Restoration Plan: Buffer to College Brook & to Faculty Neighborhood

Site Plan and Conditional Use Permit Review,
Mill Plaza / Colonial Durham Associates

For the Planning Board, Durham, NH
February 3, 2022
by Robin Mower

Existing Conditions

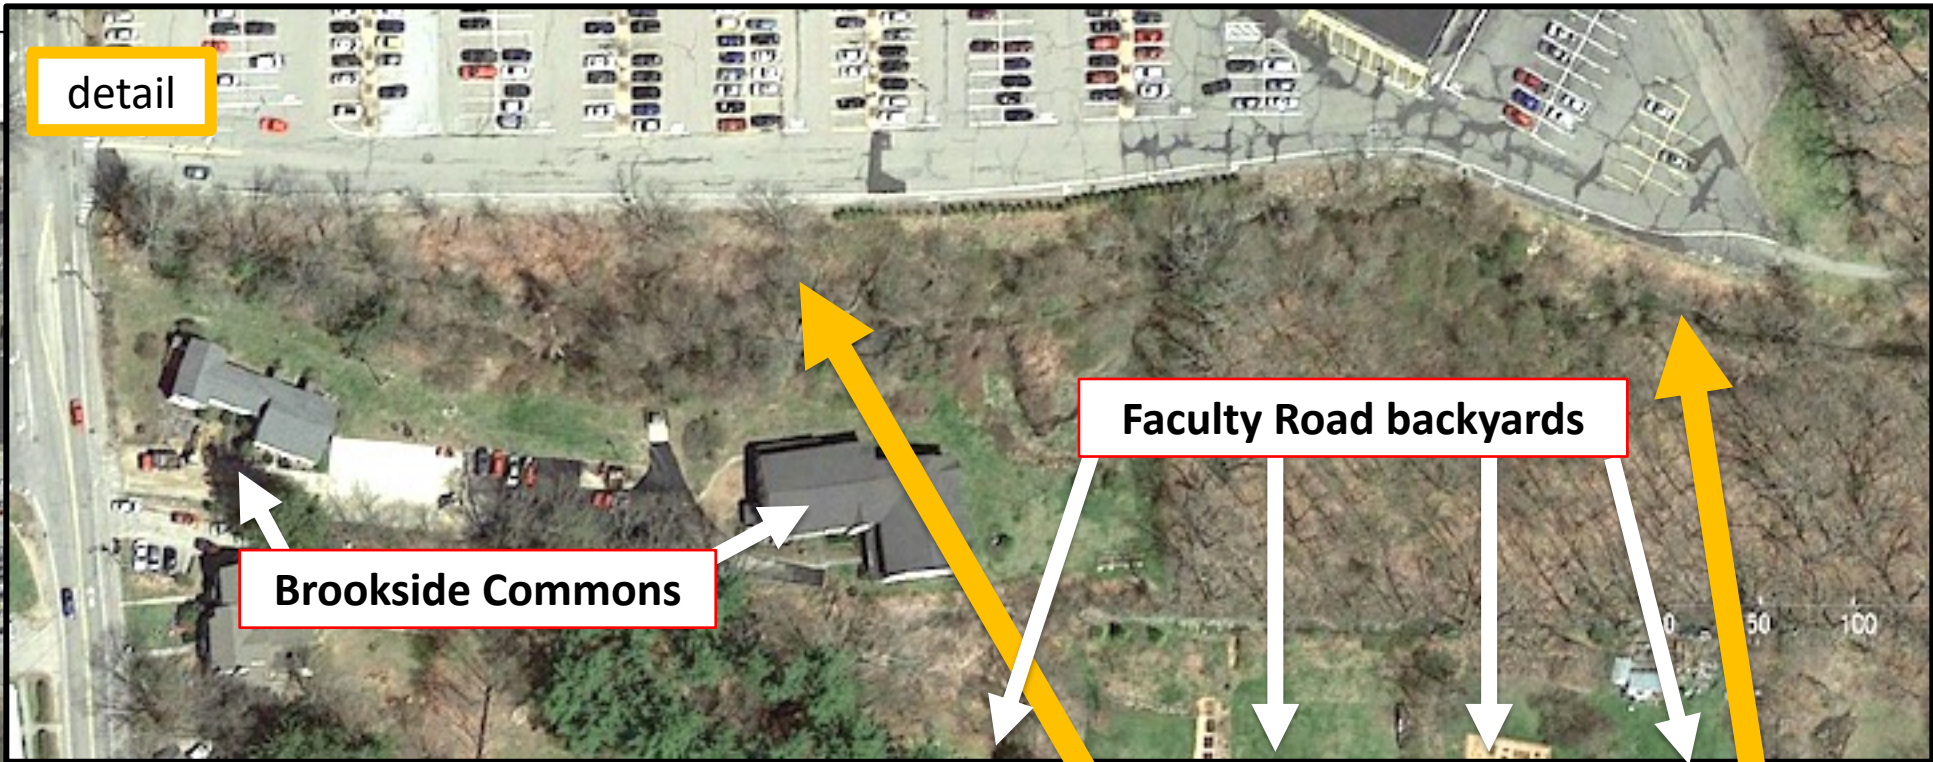
no foliage 6 months of the year

No Visual Buffer Much of the Year

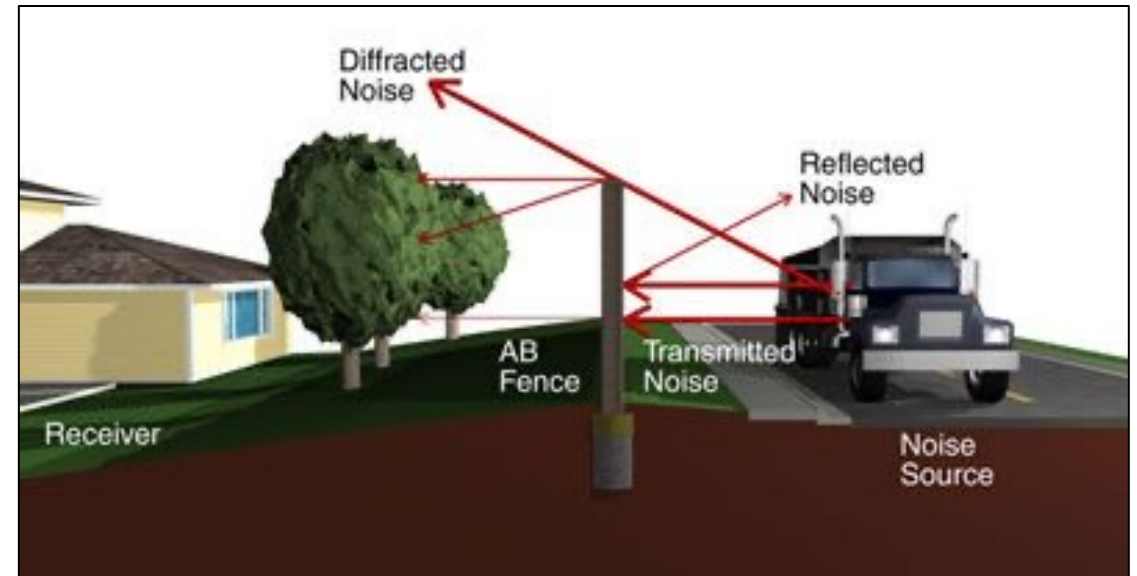
No screening foliage for 6 months of the year

How long will the vegetation provide its intended function?

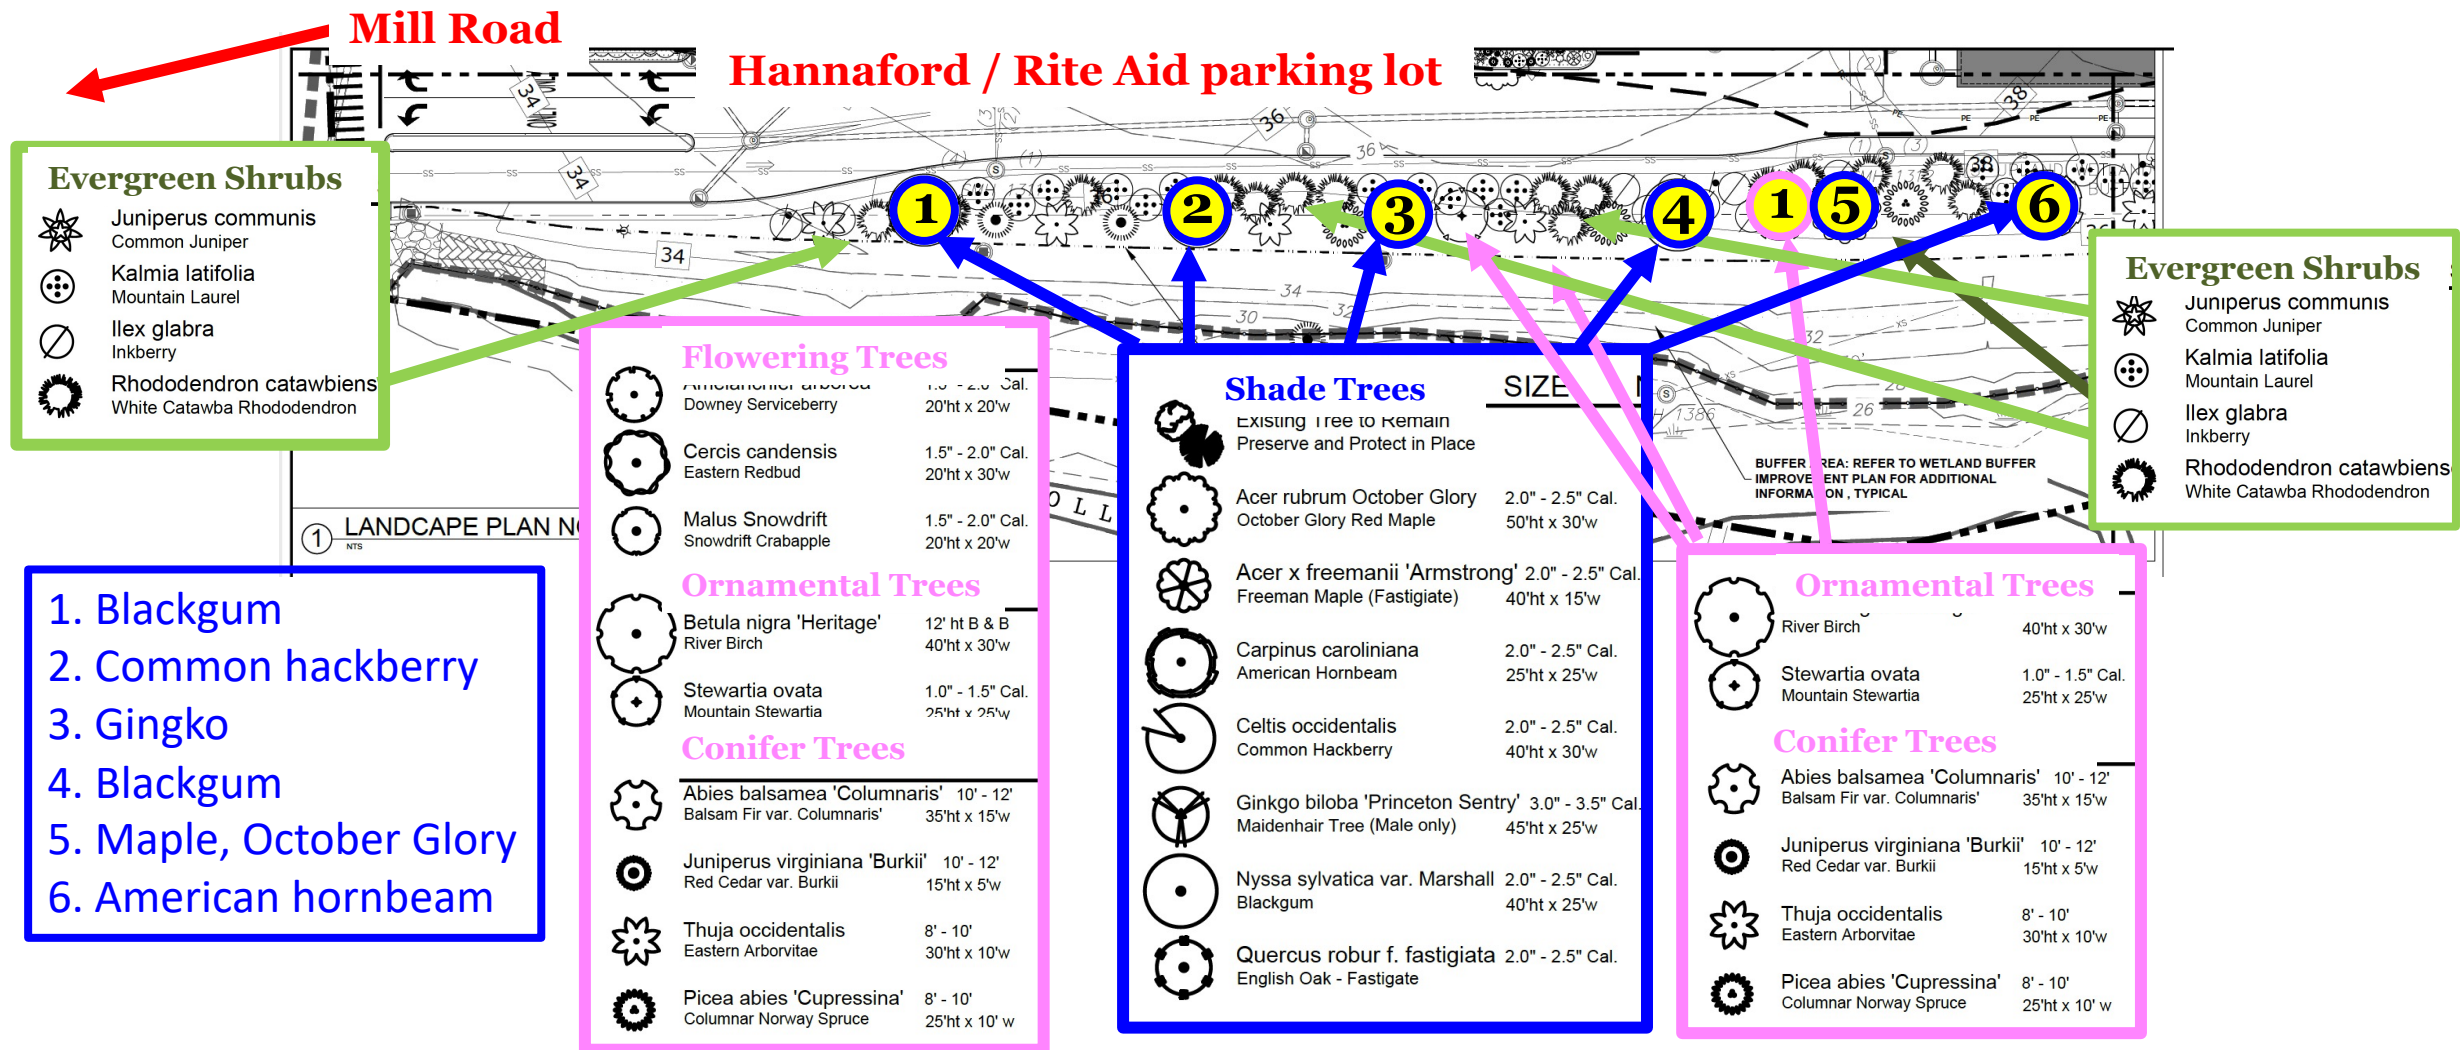
How long will the vegetation provide its intended function?

- **Deer roam** between the Plaza and the Foss Farm Neighborhood, ravaging even gardens close to houses en route.
- The southern, wooded “panhandle” area of the site is part of a larger stretch of woods toward Mill Pond.
- **Brookside Commons** routinely sees deer in that wooded panhandle.
- Daylilies in my back and front yards at 11 **Faculty Road** were routinely devoured. No one on Faculty Road plants tulips, having learned from experience.
- Former neighbors at 15 Faculty Road noted that as many as **7 deer routinely slept in their backyard.**

Sheet L2.3, top: "Landscape Plan Northeast" – south of Building B

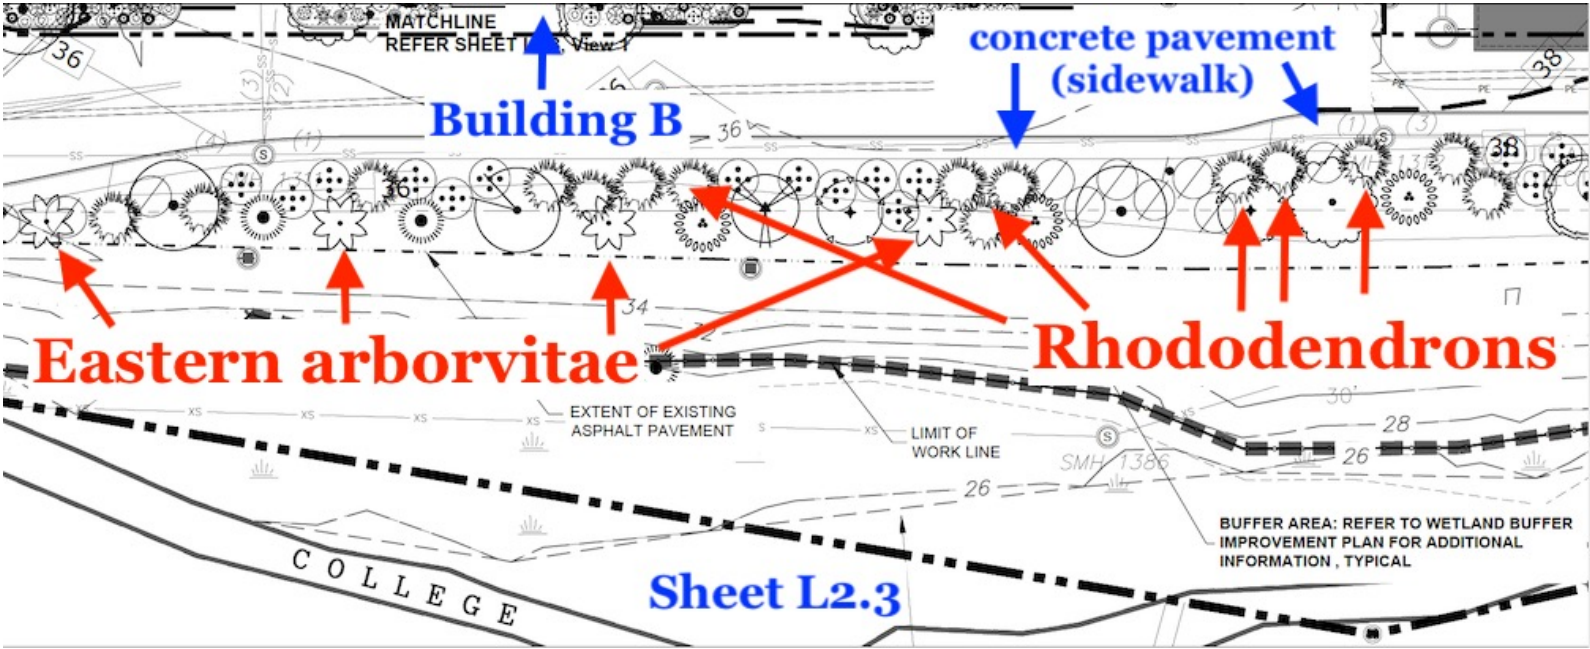
Species proposed that are attractive to deer

- **Eastern arborvitae** (“American arborvitae”: 9 on plan) and **rhododendrons** (21 on plan) are particularly vulnerable to deer predation, even if near a road or traffic. Both species are frequently severely damaged. “If you like the appearance of arborvitae and want a shrub that deer won’t eat, your best bet is Eastern red cedar (although they may still nibble on the lower foliage),” notes Rutgers ([Landscape Plants Rated by Deer Resistance](#)).
- **Cultivated daylilies**, such as the proposed Lemon Lily (34 on the plan), are deer treats. (Deer ignore wild daylilies (*hemerocallis fulva*), also proposed.)
- **Rhododendrons also require other conditions** such as moist organic soil, protection from sun, wind, and road salt. **Dogwood**: Gray (“Panicked”) Dogwood [may occasionally be severely damaged by deer](#).

* mislabeled; should be "Southwest"
